UNITED STATES
NUCLEAR REGULATORY COMMISSION
WASHINGTON, D. C. 20555

GEORGIA INSTITUTE OF TECHNOLOGY

AMENDMENT TO FACILITY OPERATING LICENSE

Amendment No. 6
License No. R-97

FIGURE 6.1 Georgia Tech Organization for Management and Operation of GTRR

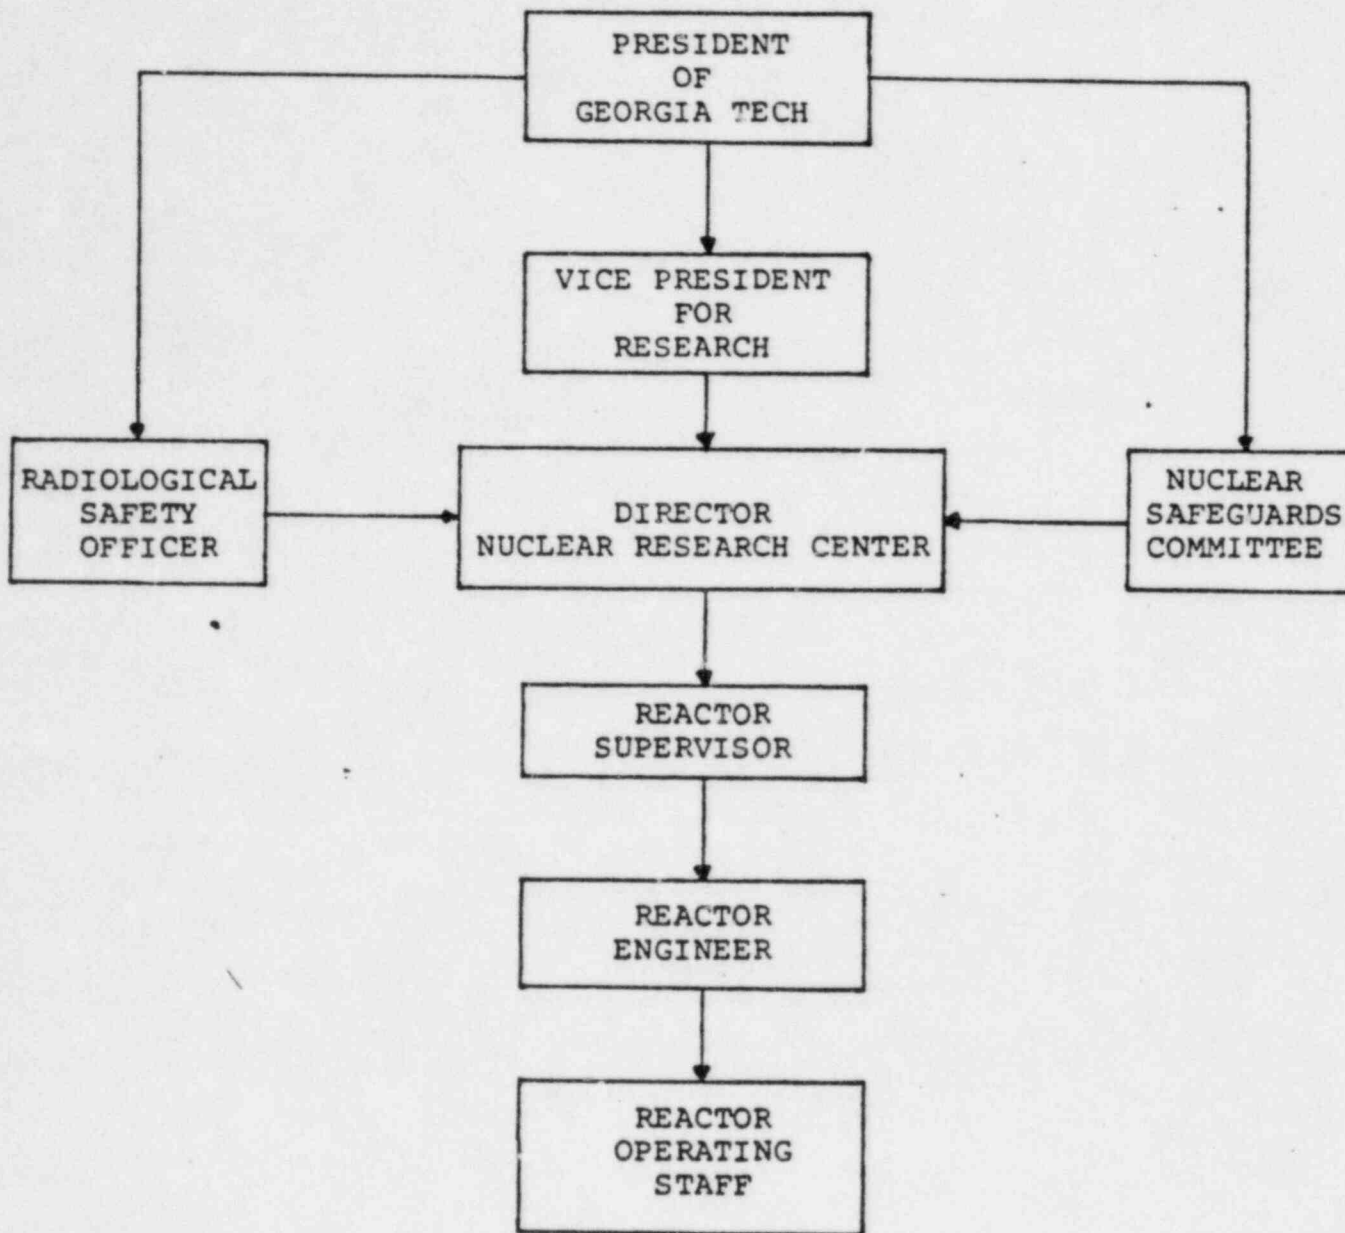
Changes on the revised pages are identified by marginal lines.
